SE141-114 Type A Thermocouple TC2-TC2

SUBJECT: Subcontract S005242-F
Rapid Response Change to Type A Castings – Thermocouple Hole

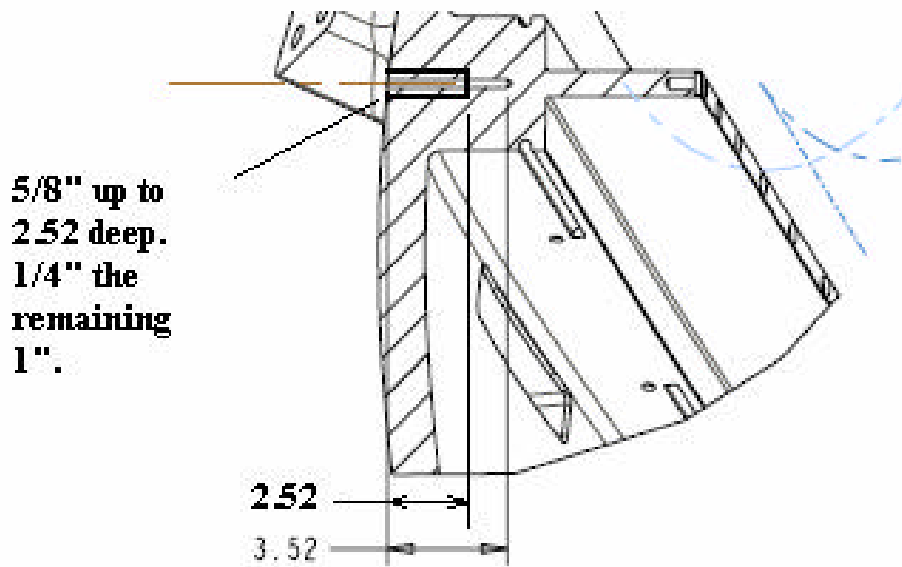
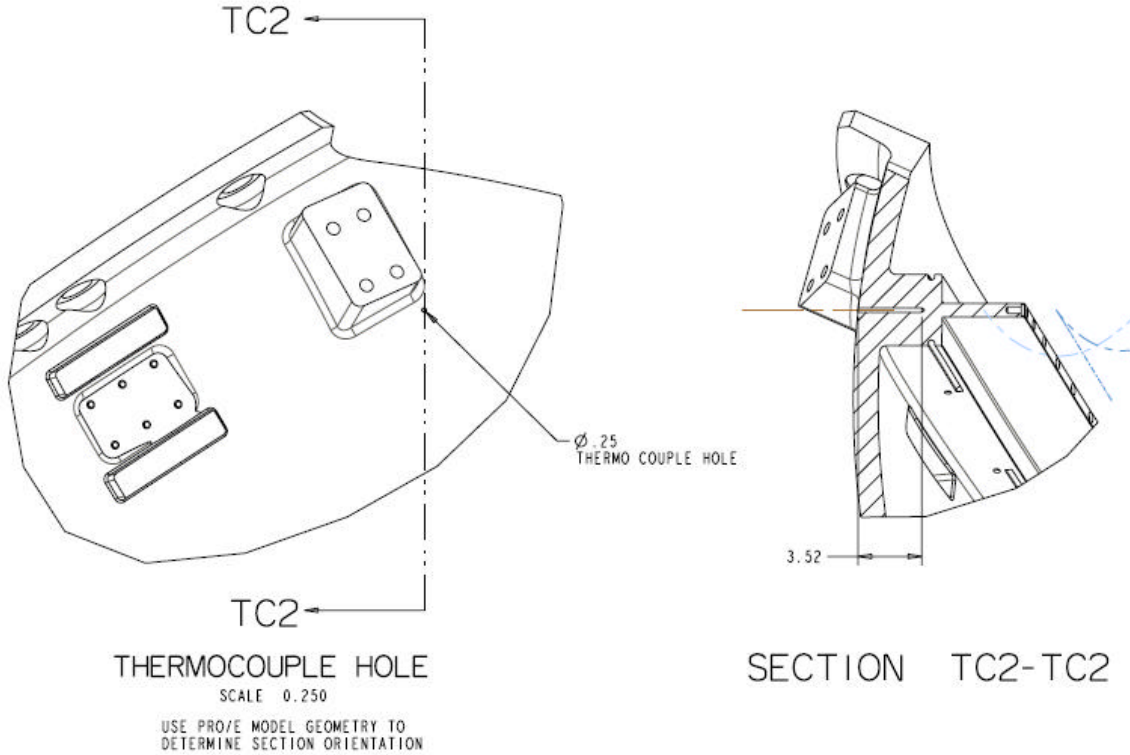
We are requesting a change to the thermocouple in section TC2-TC2 of drawing SE141-114 sheet 9 similar to what has already been approved on the thermocouple at location TC1-TC1.

To facilitate drilling of the thermocouple hole shown in drawing Number SE 141-114, sheet 9, the diameter of the 8.2 inch deep thermocouple hole will be increased to 5/8" for the first 7.2 inches of depth, followed by a diameter of 0.25 inch for the remaining 1 inch depth.
